PLANNING COMMISSION
DATE: 4/13/15
AGENDA ITEM: 5A – BUSINESS ITEM
CASE # 2015-13

ITEM: Hunter's Crossing 2nd Addition Final Plat

Re: Hunters Crossing 2nd Addition
Construction Plan Review

Re: 5th Street North Utility & Street
Construction Plan Review
(Hunters Crossing 2nd Addition)

SANITARY SEWER AND WATERMAIN CONSTRUCTION

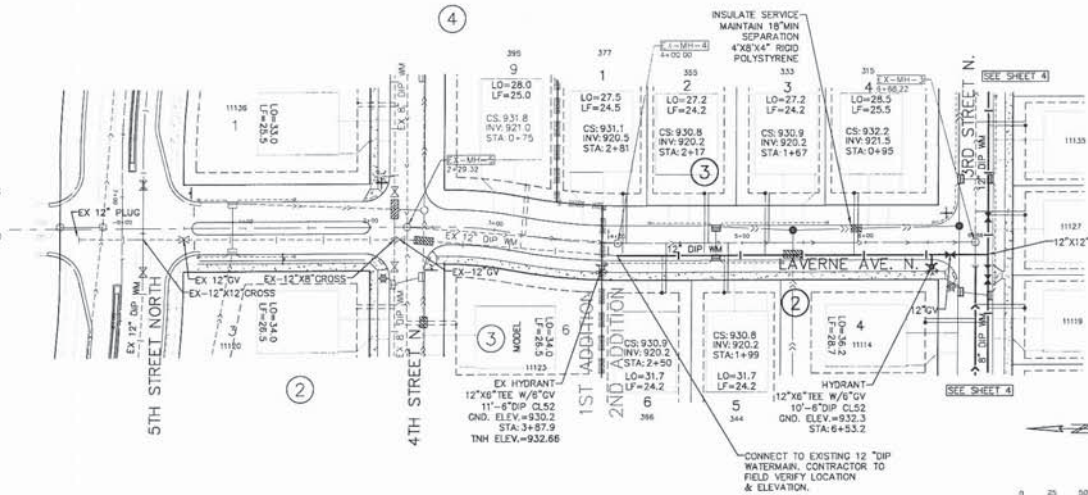
- Sheet 2 – Add a note to EX-MH-2-1 to relocate the off road structure marker to a minimum 2 feet off the bituminous trail.
- Sheet 4 – Use as-built data at EX-MH-3 to label slope and invert to proposed MH-31 and MH-32.
- Sheet 4 – Use as-built data at EX-MH-2 to label slope and invert to proposed MH-41.
- Sheet 4 – Correct stationing of proposed service crossing and add risers for all services deeper than 15 feet from EX-MH-2 to MH-41.

- Sheet 4 – 3rd Street N watermain must be relocated the north side of the street per City Design Standards.
- Sheet 4 – Revise 6-inch gate valve to 8-inch gate valve and remove reducer for the Outlot A watermain stub.

STORM SEWER CONSTRUCTION

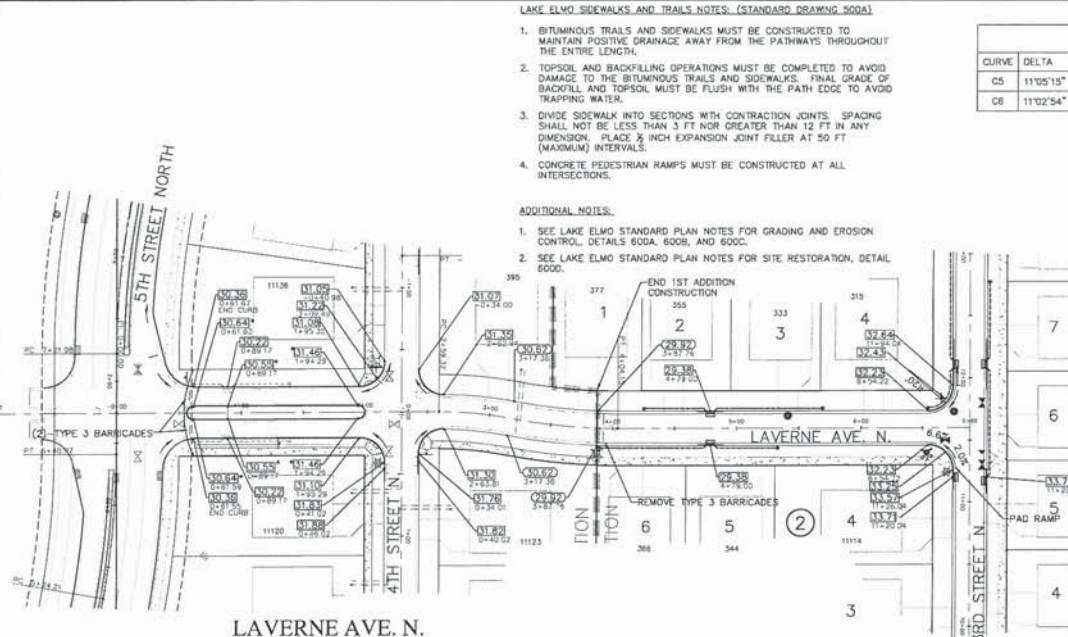
- Update Storm Sewer Chart to be consistent with the Plan.
- Standard Detail No. 404 must be included in the Plan.
- Sheet 5 – Extend draitile out of CBMH 221 and CB 222 to a minimum distance of 100 feet for each run.
- Sheet 6 – Include draitile with clean outs from CB-205 and CB-206 to the west 100' with clean outs.
- Sheet 6 – Terminate the draitile at 50 feet that runs east out of CB-203A and CB-203B. (This is the location of the high point in the street profile.)
- Sheet 6 – Extend draitile out of CBMH 202 to a minimum 100 feet in each direction.
- Sheet 7 – Add label and invert elevation for FES-250 in profile.

TYPICAL SECTIONS

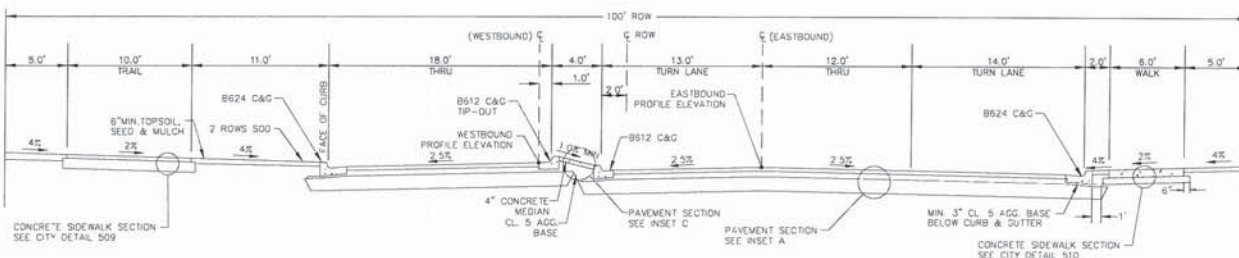
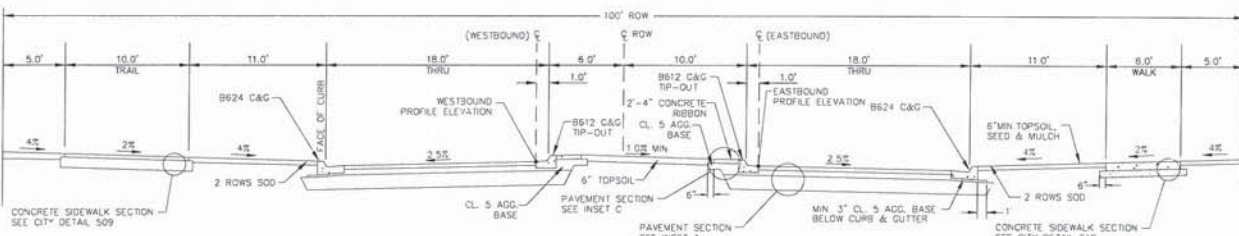
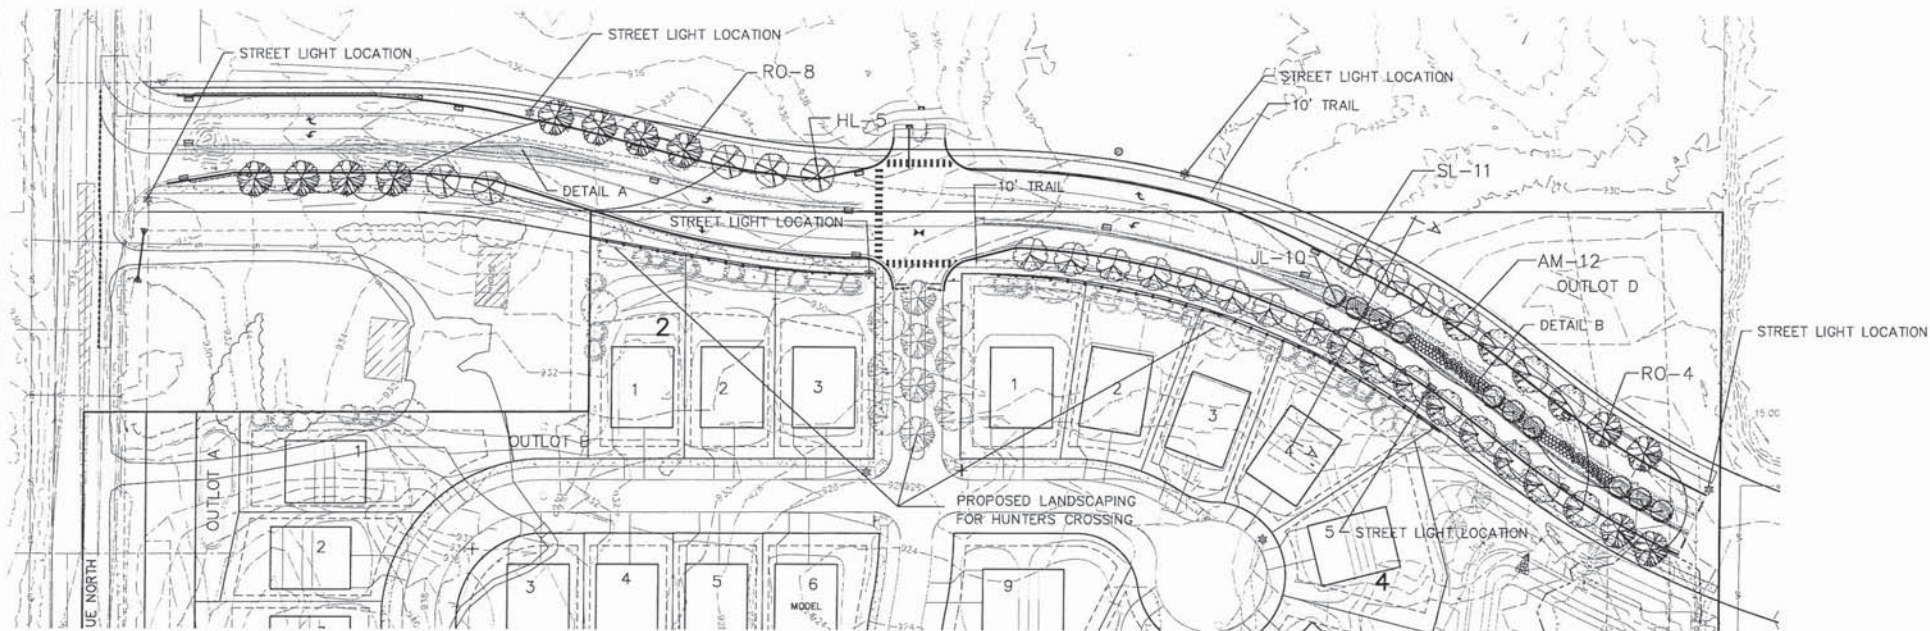
- Sheet 3 and 6 – Typical Sections and Details must be updated per the 5th Street Design Details dated March 2015. The typical sections must show the sidewalk and trail clear zones, the 10-foot drainage and utility

easements on either side of the R/W, and the depressed center median with daintile. The new 5th street pavement section detail should be used with all other information corrected to comply with the City typical sections and details.

LANDSCAPE PLAN

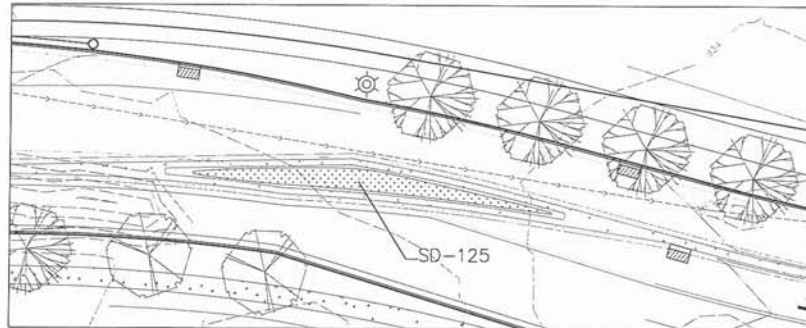
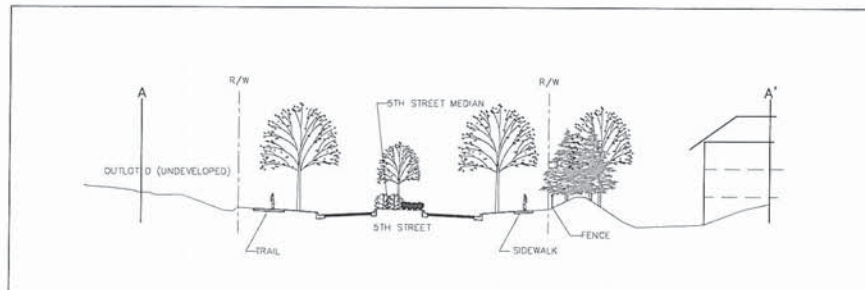
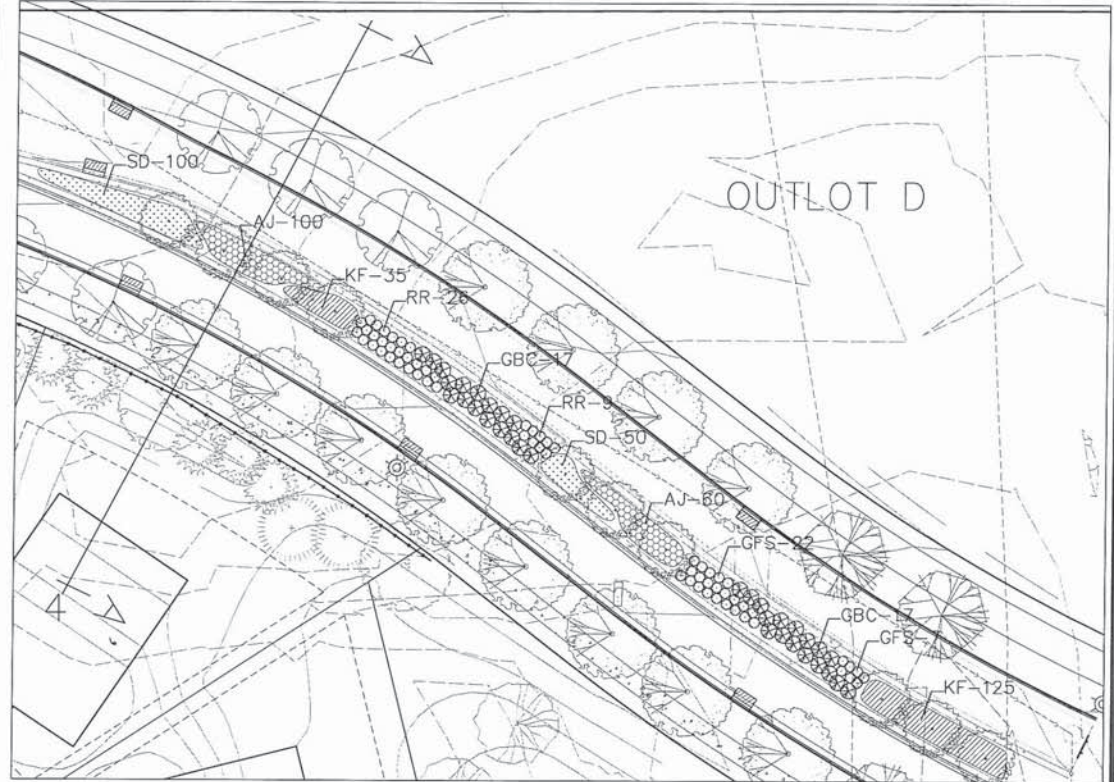
- Sheet L1 and L2 – Landscape plans must be revised to meet 5th Street Design Details dated March 2015. Landscape review comments will be provided under separate memorandum from the City’s Landscape Architect.
